Informal document No. GRSP-45-07
(45th GRSP, 25-29 May 2009,
agenda item 14(a))

REGULATION No 29
(Cabs of Commercial Vehicles)

Proposal for revision of the Regulation

**Proposal for revision of UN ECE Regulation No 29
Transmitted by the experts of the Russian Federation**

Fig. 1 – Front impact test (test A).

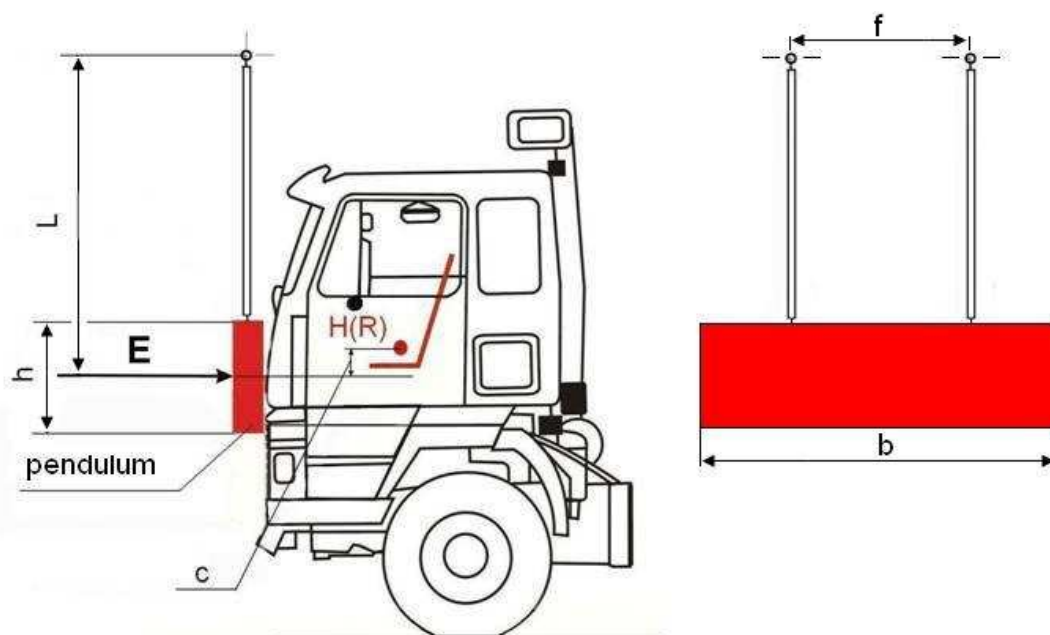
For the front impact test, see figure 1.

- 4.1.1. The swing-bob shall be made of steel and its mass shall be evenly-distributed; its mass shall **not be less than 1,500 \pm 250 kg**. Its striking surface, rectangular and flat, shall be **b = 2,500 mm** wide and **h = 800 mm** high. Its edges shall be rounded to a radius of curvature of not less than 15 mm.

- 4.1.2. The swing-bob assembly shall be of rigid construction. The swing-bob shall be freely suspended by two beams rigidly attached to it and spaced not less than **f = 1,000 mm** apart. ~~The beams shall be of "I" section with a web height of not less than 100 mm or shall be of a section having at least an equivalent moment of inertia.~~ The beams shall not be less than **L = 3,500 mm** long from the axis of suspension to the geometric centre of the bob.

- 4.1.3.2. its centre of gravity is **c=50 +5/ - 0 mm** below the R point of the driver's seat, and
- 4.1.3.3. its centre of gravity is in the median longitudinal plane of the vehicle.

- 4.1.4. The swing-bob shall strike the cab at the front in the direction towards the rear of the cab. The direction of impact shall be horizontal and shall be parallel to the median longitudinal plane of the vehicle. The impact energy shall be **55 kJ** ~~3,000 mkgf for vehicles of a permissible maximum mass up to 7,000 kg and 4,500 mkgf for vehicles for which the permissible maximum mass exceeds this value.~~

Fig. 2. – Front pillar impact test (Test B).

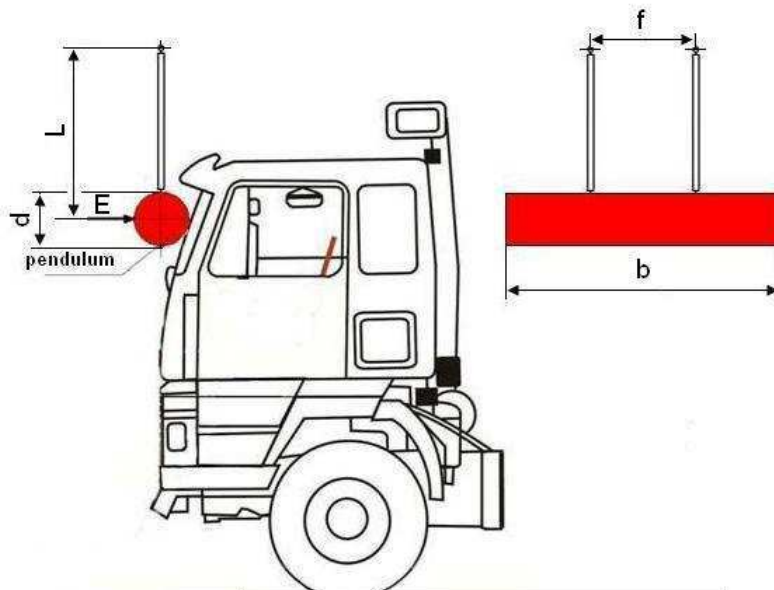
For the cab's front pillar impact test, see figure 2.

- 5.1.1. The swing-bob shall be made of steel and its mass shall be evenly-distributed; its mass shall not be less than **1,000 kg**. The swing-bob shall be cylindrical with the diameter of cylinder **d = 600 mm** and the width **b** of not less than **2,500 mm**. Its edges shall be rounded to a radius of curvature of not less than 15 mm.
- 5.1.2. The swing-bob assembly shall be of rigid construction. The swing-bob shall be freely suspended by two beams rigidly attached to it and spaced not less than **f = 1,000 mm** apart. ~~The beams shall be of "I" section with a web height of not less than 100 mm or shall be of a section having at least an equivalent moment of inertia.~~ The beams shall not be less than **L = 3,500 mm** long from the axis of suspension to the geometric centre of the bob.

- 5.1.3. The swing-bob shall be so positioned that in the vertical position it shall be capable to strike the middle of the windscreen pillars' height in the direction towards the rear of the cab. The direction of impact shall be horizontal and shall be parallel to the median longitudinal plane of the vehicle. The impact energy shall be 29.4 kJ.
6. Roof strength test (Test B C)

Fig. 3. Roof strength test (Test C).

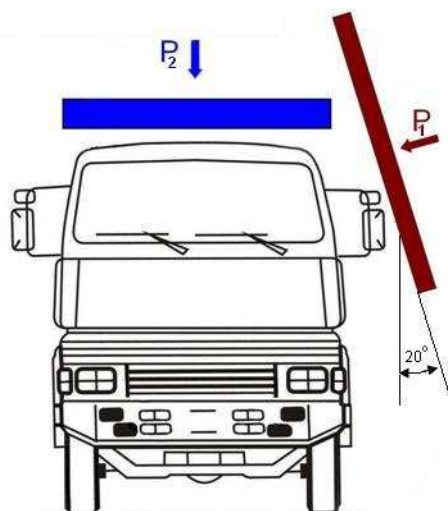
For the roof strength test, see figure 3.

The roof strength test is aimed at evaluating the resistance of a cab to deformations occurring in a 180° overturn. The load is divided into two phases: the dynamic pre-load P_1 simulating the lateral load applied to the cab top at the moment the vehicle overturns 90° and more; and the static load on the roof P_2 , simulating the load on the cab roof of the overturned vehicle. For both test phases the same cab shall be used.

6.1. In the phase of dynamic load, the cab top shall be stroked with the rigid plate positioned at the angle of 20° to the vertical and the impact energy shall equal to 17.6 kJ. The movable part can be the plate suspended by two beams (the swing-bob), or the plate rigidly attached to a movable platform, or the cab mounted on a movable chassis frame. The plate dimensions shall be capable to provide a contact with the cab of only an inner surface of the plate.

6.2. In the phase of load on the roof, the cab roof shall be subject to a static load by means of a flat rigid plate simulating the ground surface that is in contact with the cab roof of the overturned vehicle. The plate shall be parallel to the horizontal bearing surface and shall move parallel to the vertical plane of the vehicle. The plate shall be large enough and shall be positioned in such a manner that the cab is in contact with only the inner surface of the plate, but not its edges.

The roof of the cab shall withstand a static load corresponding to the maximum mass authorized for the front axle or axles of the vehicle, subject to a maximum of ~~10 tonnes~~ 98 kN. ~~This load shall be distributed uniformly over all the bearing members of the roof structure of the driver's cab or compartment by means of a suitably shaped rigid former.~~

Fig. 4. – Rear-wall strength test

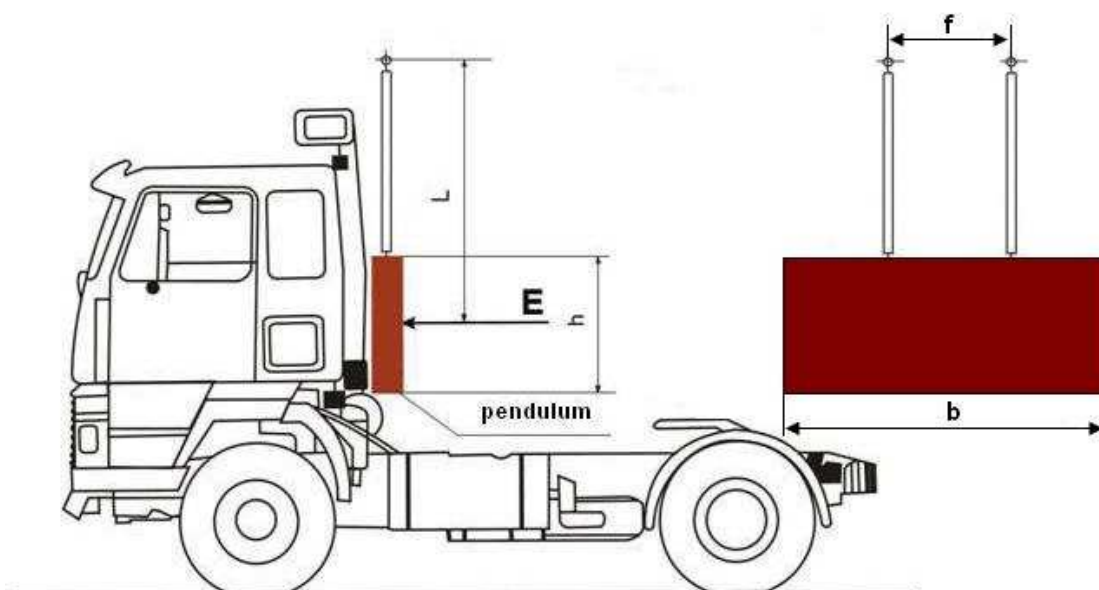
For the rear-wall strength test, see figure 4.

~~The rear wall of the cab shall be capable of withstanding a static load of 200 kgf per tonne of permissible useful load. This load shall be applied by means of a rigid barrier perpendicular to the longitudinal median axis of the vehicle, covering at least the whole of the cab rear wall situated above the chassis frame, and moving parallel to that axis.~~

- 7.1.1.** The swing-bob shall be made of steel and its mass shall be evenly-distributed; its mass shall not be less than 1,500 kg. Its striking surface, rectangular and flat, shall be $b = 2,500$ mm wide and $h = 800$ mm high. Its edges shall be rounded to a radius of curvature of not less than 15 mm.

- 7.1.2.** The swing-bob assembly shall be of rigid construction. The swing-bob shall be freely suspended by two beams rigidly attached to it and spaced not less than $f = 1,000$ mm apart. The beams shall be of "I" section with a web height of not less than 100 mm or shall be of a section having at least an equivalent moment of inertia. The beams shall not be less than $L = 3,500$ mm long from the axis of suspension to the geometric centre of the bob.

- 7.1.4.** The swing-bob shall strike the cab in the direction towards the rear-wall. The impact energy shall be 29.4 kJ.
